Project	IEEE 802.16 Broadband Wireless Access Working Group < http://ieee802.org/16 >
Title	Corrections to ACR for 802.16-2004
Date Submitted	2005-07-15
Source(s)	Darcy Poulin [mailto:dp@sige.com] SiGe Semiconductor
Re:	<u>Response to Sponsor Ballot on IEEE802.16-2004/Cor1/D3 document</u>
Abstract	This document describes the reasons why ACR is incorrect in the current version of the 802.16 standard.
Purpose	This document is background material for a correction to ACR required in 802.16-2004
Notice	This document has been prepared to assist IEEE 802.16. It is offered as a basis for discussion and is not binding on the contributing individual(s) or organization(s). The material in this document is subject to change in form and content after further study. The contributor(s) reserve(s) the right to add, amend or withdraw material contained herein.
Release	The contributor grants a free, irrevocable license to the IEEE to incorporate material contained in this contribution, and any modifications thereof, in the creation of an IEEE Standards publication; to copyright in the IEEE's name any IEEE Standards publication even though it may include portions of this contribution; and at the IEEE

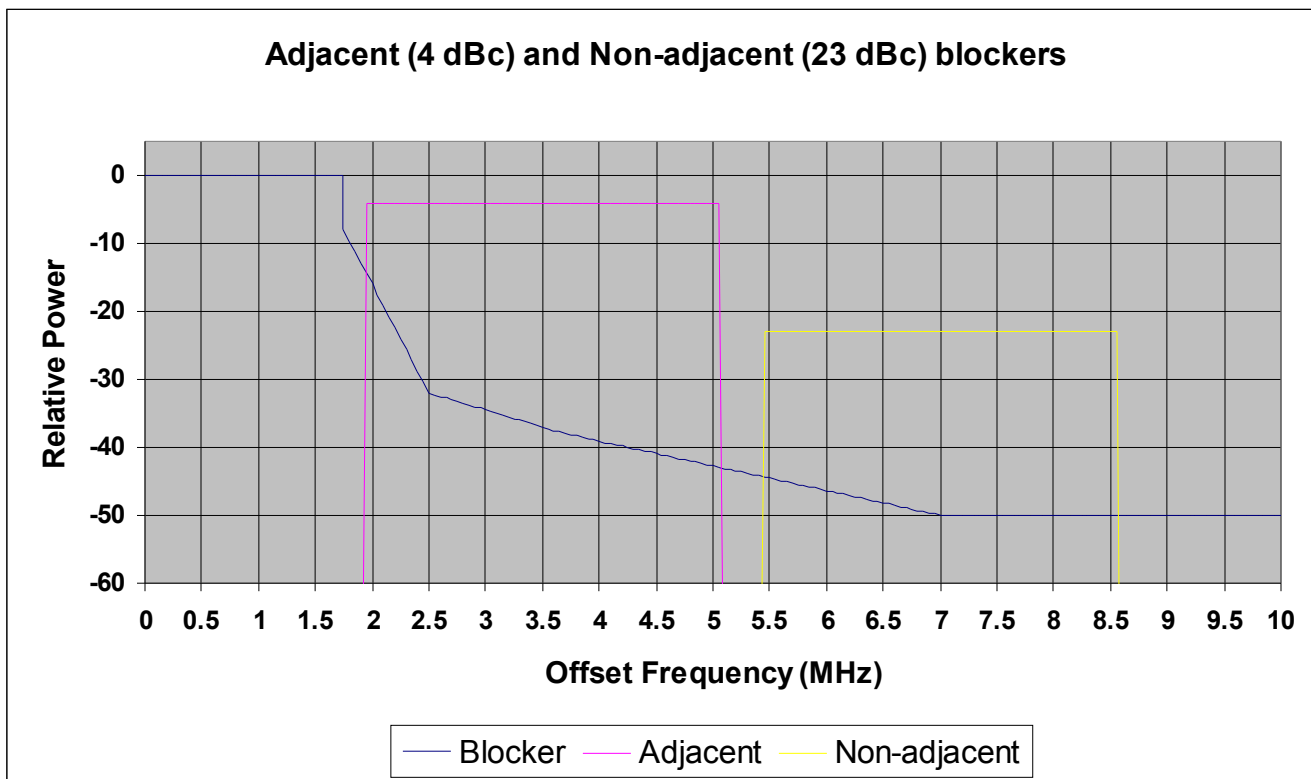
The graph below shows details. For the adjacent blocker case, the red curve represents the desired signal, while the blue curve is the spectral mask of the blocker. The blocker is at a power level 4 dB above that of the desired signal. The integrated power from the blocker that appears in the passband of the red signal is -22.6 dBm. Since the desired signal is at -4dBm, the SNR will be approximately 18.6 dB. However, the receiver requires an SNR of 25 dB (OFDMA) or 26 dB (OFDM) in order to correctly demodulate the 64QAM-3/4 signal. The noise from the blocker is too high if the blocker is 4 dB above the desired signal.

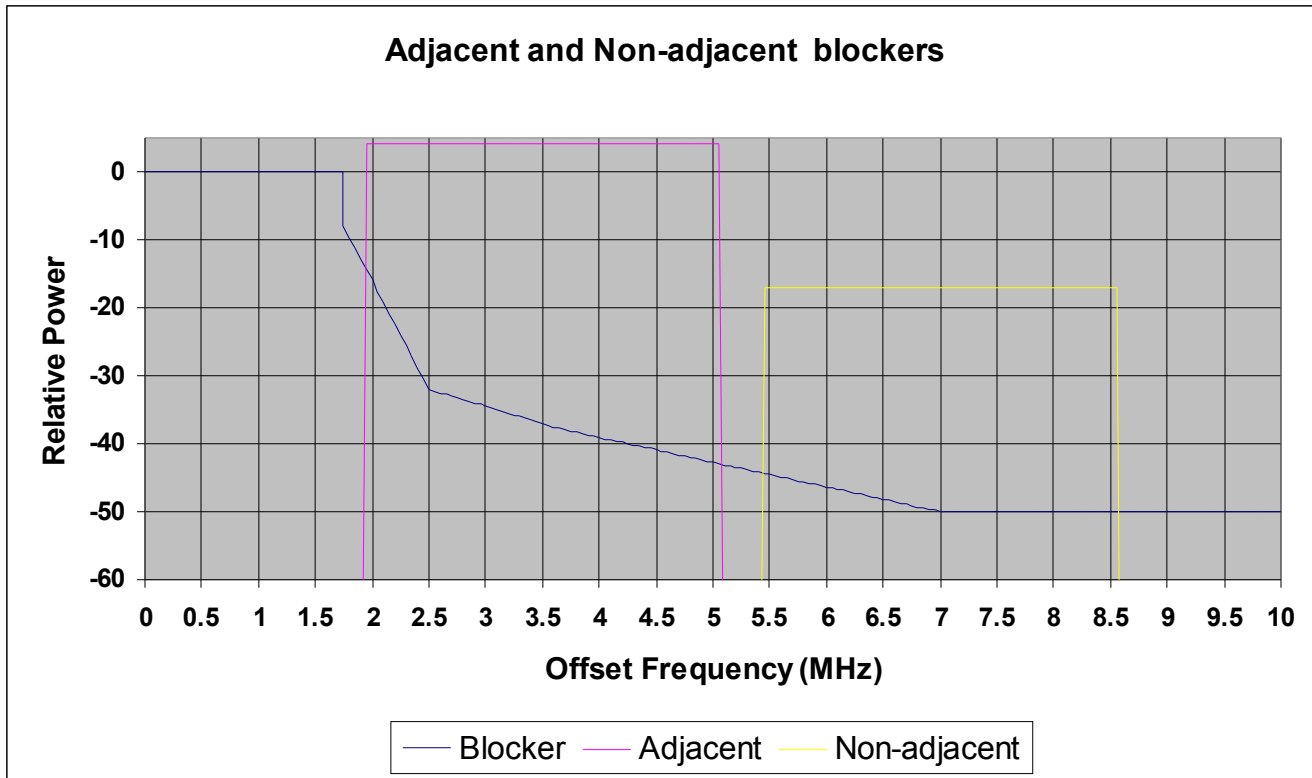
For the non-adjacent blocker, a similar situation exists. the blocker is still the blue curve. The desired signal is now the yellow curve. It is set so that it is 23 dB below the power level of the blocker. The integrated power of the blocker that appear in the passband of the desired signal is -43.2 dBm. Since the desired signal is at -23 dBm, the SNR is about 20.2 dB. Again, this is below the required 25 dB (OFDMA) or 26 dB (OFDM) SNR required for correct demodulation.

The curve below shows the level of the blocker and desired signals required to meet the 26 dB SNR necessary for demodulating OFDM signals. Note that the level of the desired signals has been increased by 8 dB for the alternate blocker, and by 6 dB for the non-adjacent blocker.

In order to ensure that the receiver can correctly demodulate the desired signal in the presence of adjacent and non-adjacent blockers, the specifications must be relaxed.

For OFDM, where the required SNR is 26 dB for 64QAM and 20 dB for 16QAM, we require:

Modulation	Adjacent Channel Rejection (dB)	Non-adjacent Channel Rejection (dB)
16QAM-3/4	2	23
64QAM-3/4	-4	17

For OFDMA, where the required SNR is 25 dB for 64QAM and 19 dB for 16QAM, we require:

Modulation	Adjacent Channel Rejection (dB)	Non-adjacent Channel Rejection (dB)
16QAM-3/4	3	24
64QAM-3/4	-3	18
